REMARKS

Serial No. 09/808,686

For: PRECISION ELECTRIC MITER BOX

LETTER TO THE OFFICIAL DRAFTSMAN

Fig 1

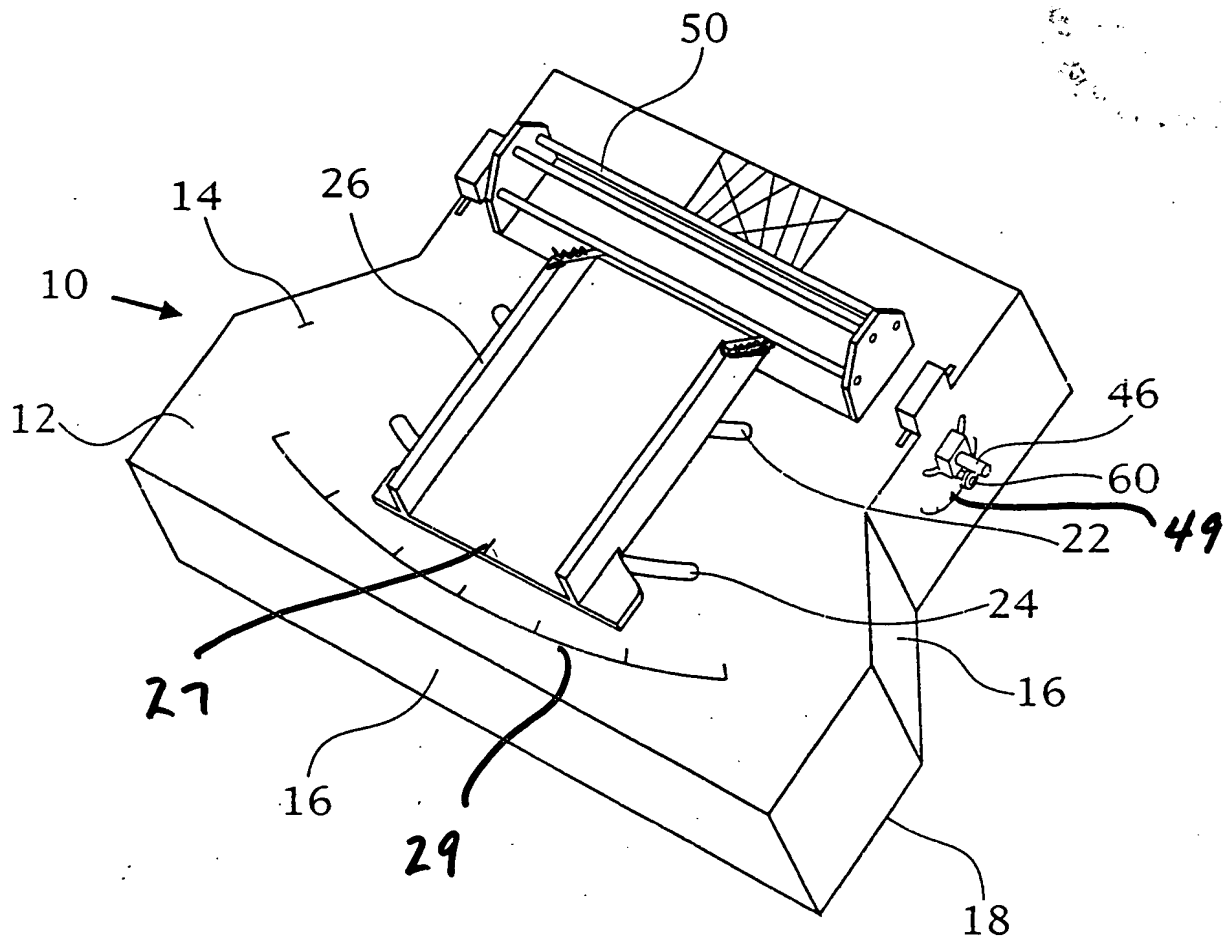
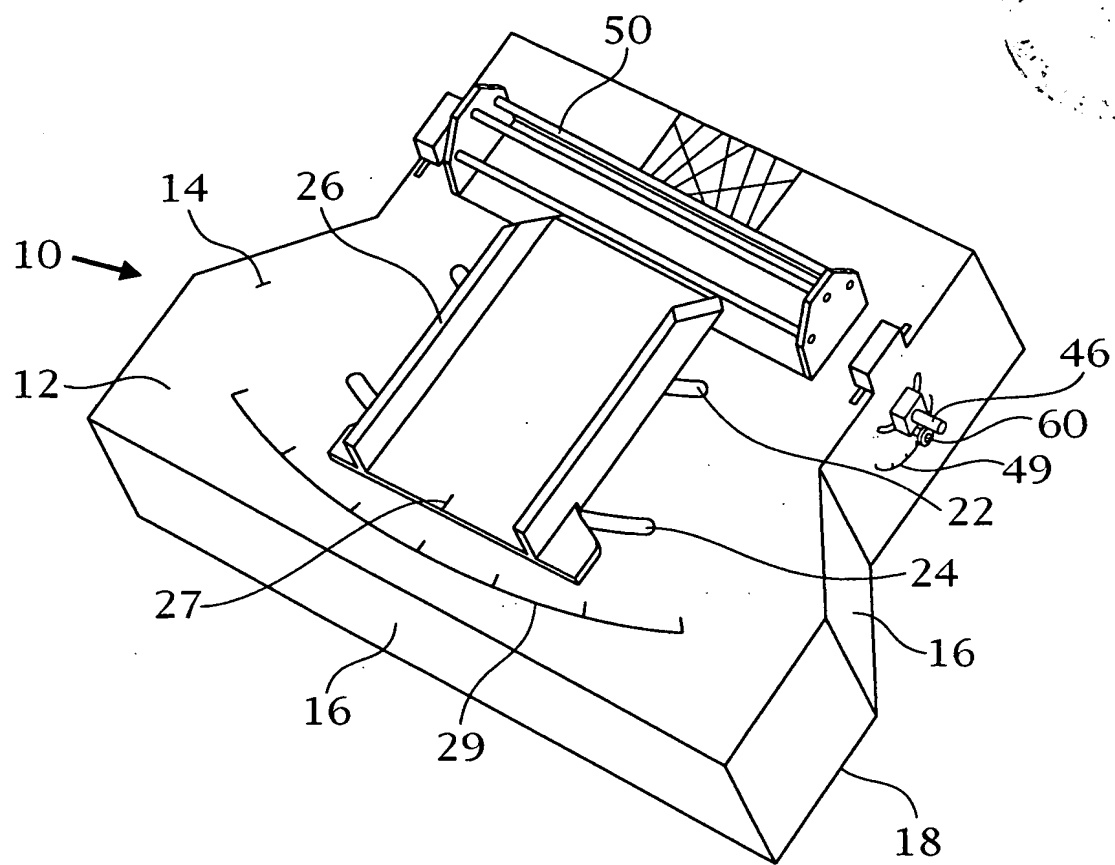
The drawings were objected to because of several informalities. The drawings have been corrected as shown in the red markings to add numerals or to correct numerals as suggested by the Examiner. In addition, it was noted that the work-holding member 26 did not accurately show the end near the elongated opening 20 having a slope downwardly toward the opening and also angularly from the outer portion toward the inner portion. Accordingly, FIGS. 1 and 4-9 have been amended. A duplicate copy of the red marked FIGS. 1, 3-11, 16, and 21-24 are enclosed to a Letter To The Official Draftsman. Also enclosed are formal drawings incorporating the corrections. Also, two sheets of drawings were submitted which included FIGS. 20-22. Please cancel the sheet of drawings which show FIGS. 20-22 and retain the sheet of drawings showing FIGS. 20-24.

As shown in FIGS. 1, 6-9, 23 and 24, due to the configuration of the first curved track 22 and the second curved track 24, the work-holding member 26 may be slidably moved with respect to the top surface 14 of the housing 12. The protrusion 36 near the second end 34 guides the second end of the work-holding member 26 within the second curved track 24. The protrusion(s) near the first end 32, guide the first end of the work-holding member 26 within the first curved track 22. In this manner, the work-holding member 26 may be moved between 45° and -45° with respect to the elongated opening 20. In order to assure a selected angular disposition of the work-holding member 26, an index 27 is placed on the base 28 [26] of the work-holding member 26 and scalar indices 29 are marked on the top surface 14 of the housing 12 such that the index 27 on the base 26 of the work-holding member 26 may be juxtapositioned to the selected angle for cutting the workpiece W as will be described. When so aligned, the first end 32 [22] of the work-holding means 26 is disposed at a corresponding angle with the elongated opening 20.

As shown in FIGS. 1, 20-22, a protector 50 is disposed on the top surface 14 of the housing over the elongated opening 20. Preferably, the protector 50 has a frame having two end pieces 52 and at least two shafts 54 therebetween. It is preferred that three shafts 54 be disposed between the end pieces 52. A cover 56 having at least a transparent portion is disposed over the frame. The transparent portion is at the top of the frame so that the cutting operation can be viewed by the operator. The protector also serves to prevent accidental contact with the cutting means 48. The protector may be removable and also may be pivotally mounted along one side so the protector 50 may be pivoted (or flipped) to permit access to the cutting means 48 [38]. In this situation, the protector 50 is interlocked to prevent operation of the cutting means 48 [38] when the protector 50 is not in place over the elongated opening 20. The cover 56 extends downwardly over the frame as a curtain to direct debris and sawdust from the cutting operation downwardly through the elongated opening 20 and away from the operator. It is preferred that the downward extending curtain portion of the cover 56 be formed with a plurality of vertical slits 57 to form fingers. The workpiece W may be easily received under the fingers of the cover 56 and the fingers are effective in directing the debris and sawdust.

Fig 3

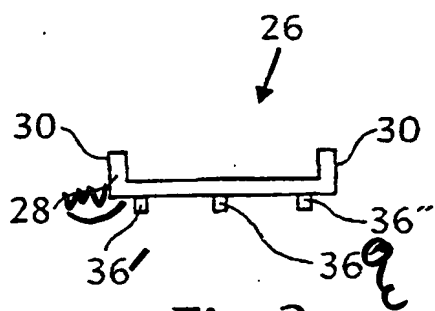
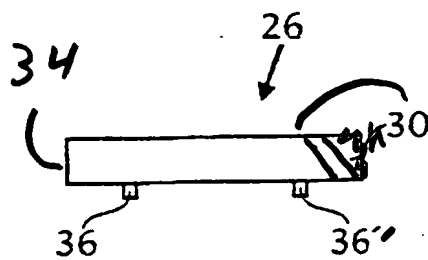
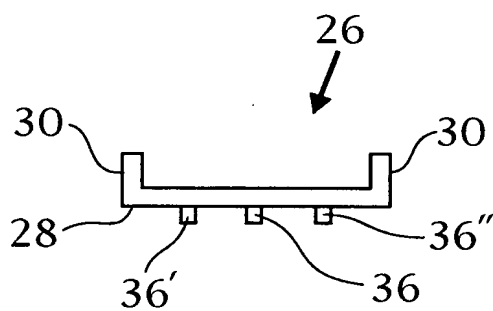
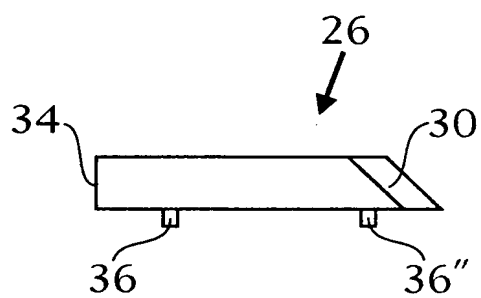
As shown in FIGS. 3-5 [3-4], a work-holding member 26 [20] has a channel shape with a base 28 and two opposite side walls 30 extending longitudinally on the base 28 between the first end 32 and the second end 34 of the work-holding member 26. The ends 32, 34 are open, having no walls formed thereon. In this manner a workpiece W may be disposed within the work-holding member 26 between the side walls 30 with the workpiece extending from the first end 32 or from both the first end 32 and the second end 34 as there is no restriction on the length of the workpiece W. The work-holding member 26 further has at least two protrusions 36 extending downwardly from the bottom surface of the base 28. The protrusions 36 [30] may be a peg or pin. One protrusion 36, disposed proximal to the second end 34 of the work-holding member 26, is received in the second curved track 24 on the top surface 14 of the housing 12. At least one, and preferably two, protrusions 36 are disposed proximal to the first end 32 of the work-holding member 26. If there are two protrusions 36', 36'', the protrusions are spaced apart. The protrusions 36', 36'' are received in the first curved track 22. If there are two protrusions, one protrusion 36' is received in one of the inverted "L" portions and the other protrusion 36'' is received in the other of the inverted "L" portions. In this manner, the work-holding member 26 is connected to the top surface 14 of the housing 12.

Fig 10

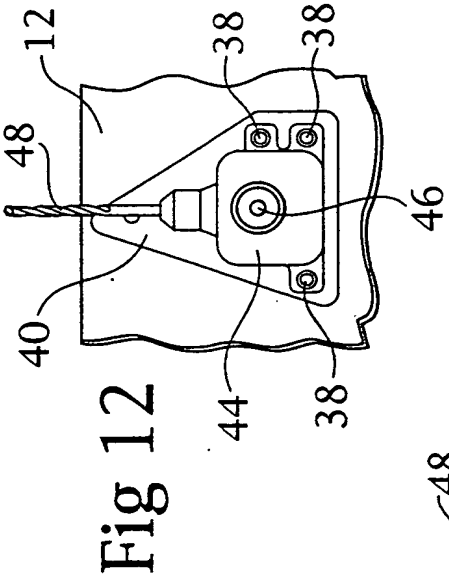
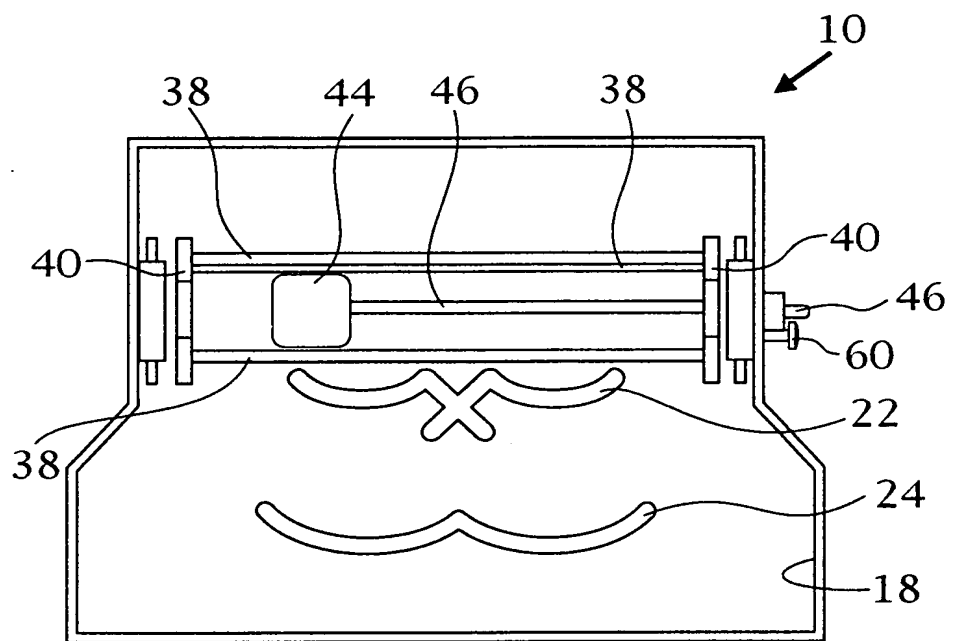
On the underside of the top surface 14 (FIG. 10), within the enclosure 18 [14], are a plurality of spaced-apart support means 38. The support means 38 are under, and approximately parallel with, the elongated opening 20. Preferably, the support means 38 are three rails each having a length greater than the length of the elongated opening 20. As shown in FIGS. 11-14, the opposite ends of each rail is mounted on a respective plate 40. Each plate 40 is pivotally connected to the housing 12.

Fig 17

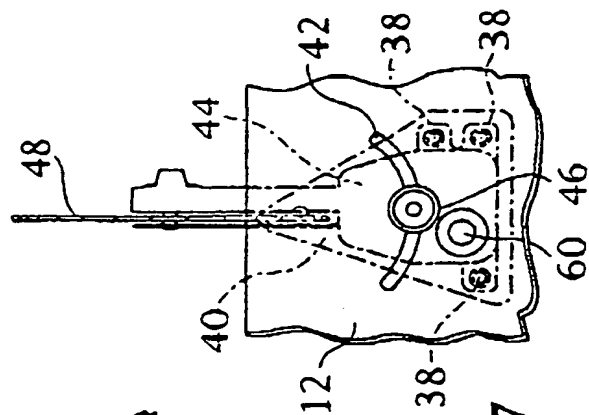
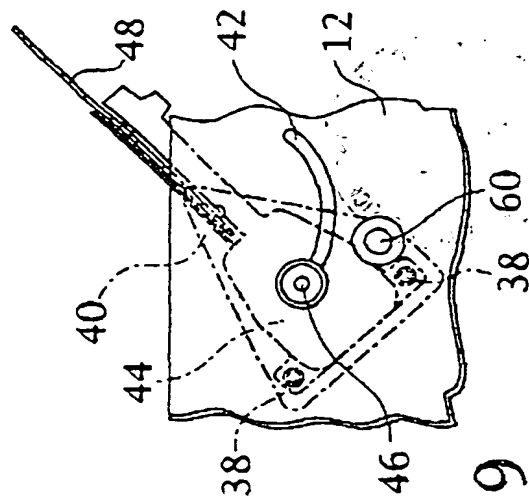
As shown in FIGS. 14, 15, 17 and 19 the plates 40 swivel as the motor, the support means, and the cutting means are moved to the selected angle (see page 9, lines 8-14 and page 11, lines 12-13). The swivel is "a coupling device that allows free turning of the parts attached to it" (Webster's New International Dictionary, Second College Edition, 1984). It is respectfully submitted that the objections to the specification have been overcome.

-- The swivel design of the cutting means 38, the motor 44 and the motor support means 38 with the plates 40 provides a -- .
